# **South San Francisco Bay Shoreline Phase I Study**

## **Addendum No. 1 to the Final Environmental Impact Statement/ Environmental Impact Report**

March 2019

**Figure 3: Original and Modified Alignment**

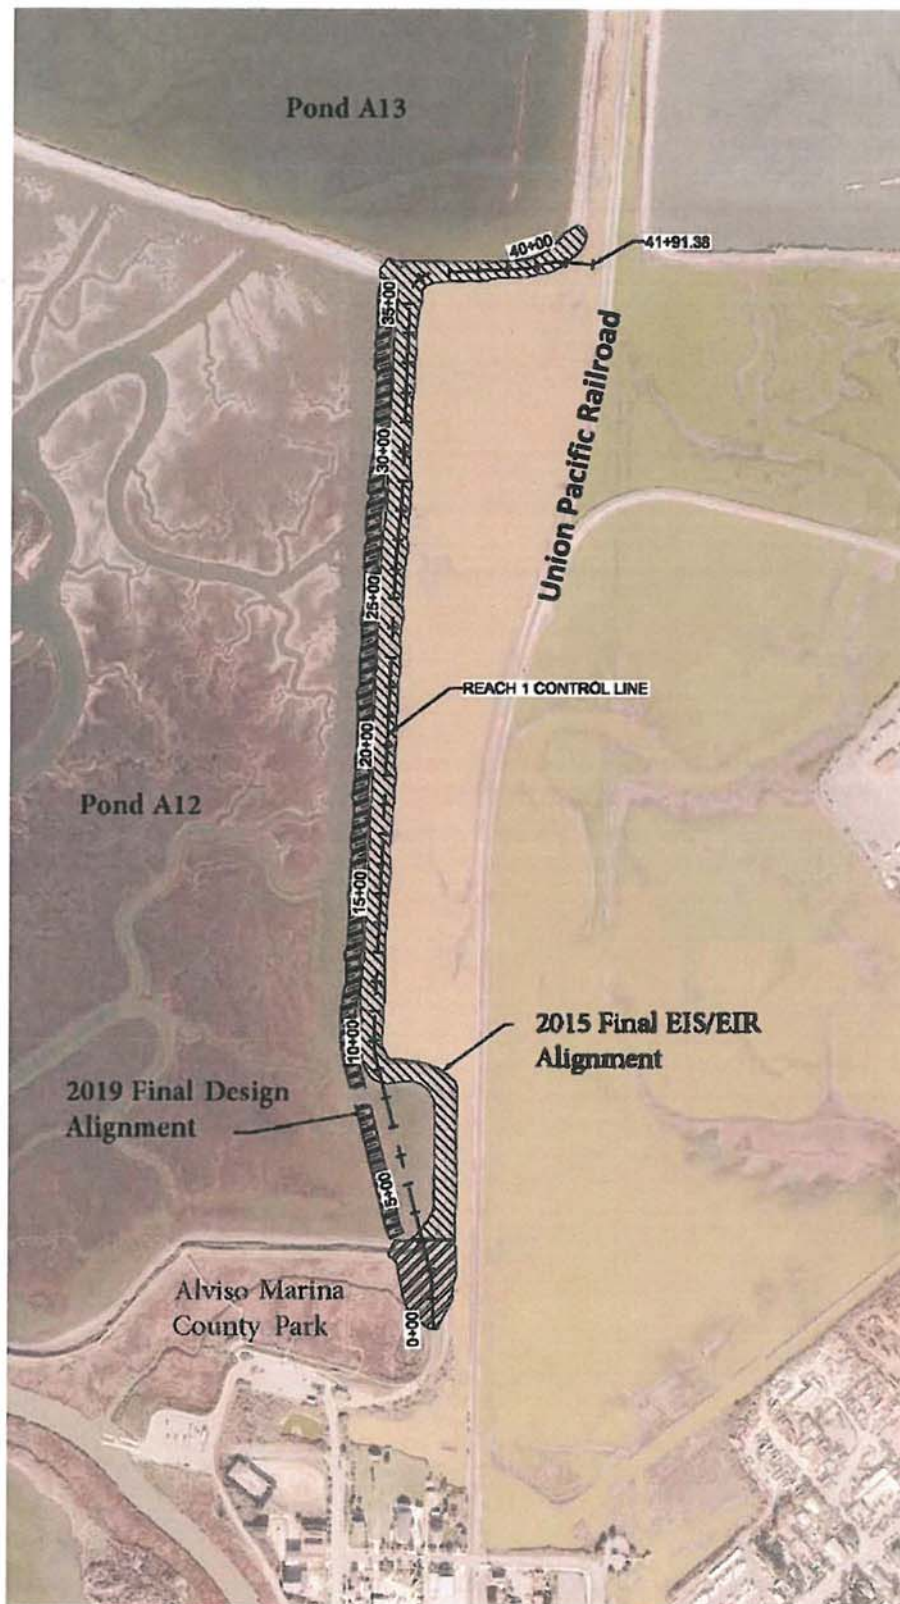
4. As a result of the USACE value engineering study, the realignment of an approximately 600-foot long segment of levee beginning at the southernmost point of Pond A12 is proposed. The new alignment would be about 200 feet shorter in length compared to the former alignment, and would avoid encroachment into the railroad right-of-way at this location and eliminate two 90-degree turns in the proposed maintenance road. See Figure 3 which shows both the original and modified alignment.

**Figure 5: Existing Recreational Facilities (Observation Deck, Alviso Slough Trail and Picnic Tables) at Alviso Marina County Park**

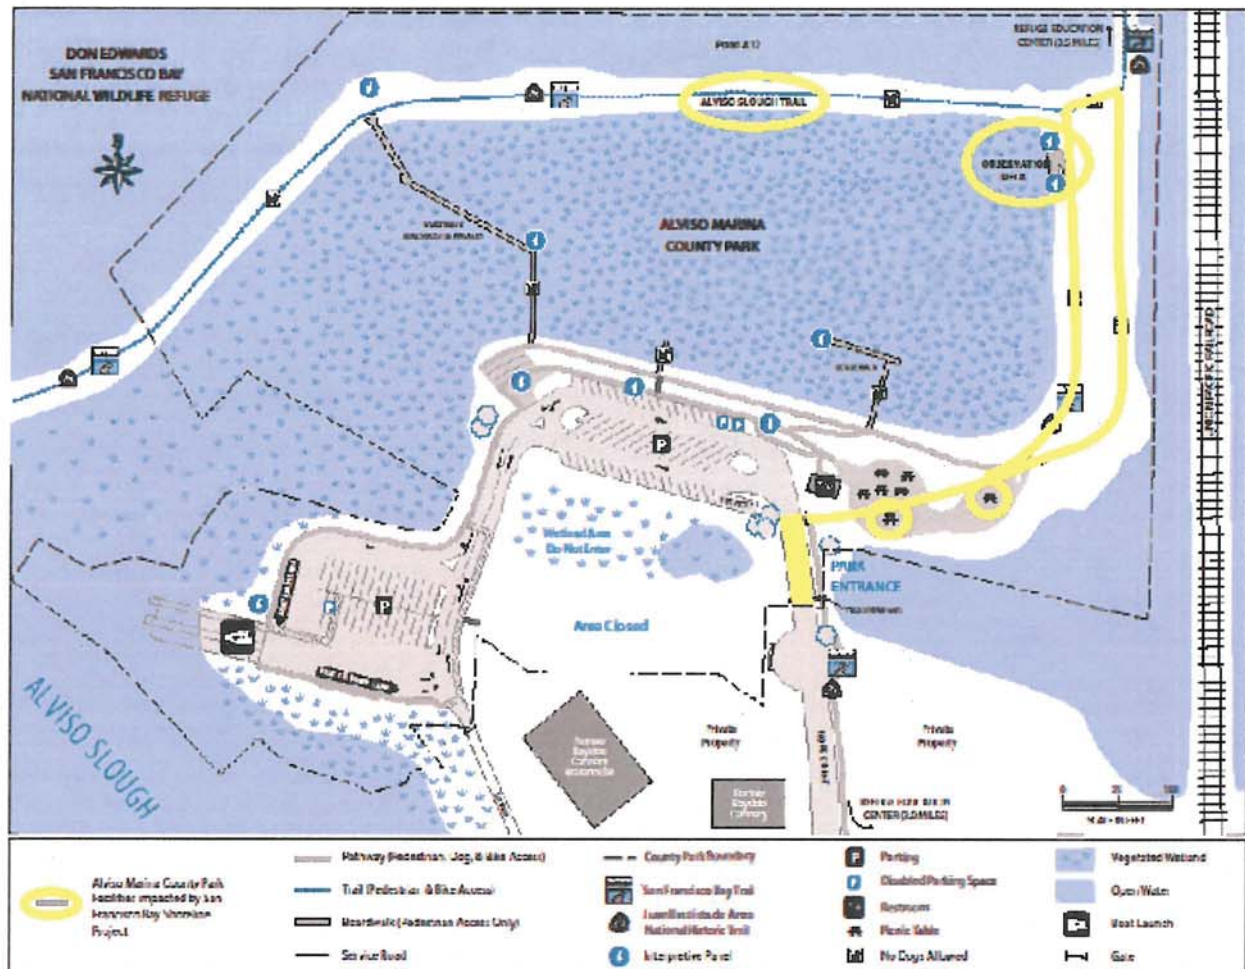
6. The existing observation deck located on the existing levee adjacent to the pedestrian trail in the northeast area of the Alviso Marina County Park, immediately east of the historic marina, would be temporarily removed during construction of the levee. Figure 5 shows the location of the existing observation deck. This deck will be replaced by either USACE or the District at a location specified by County Parks following construction of the Reach 1 levee.
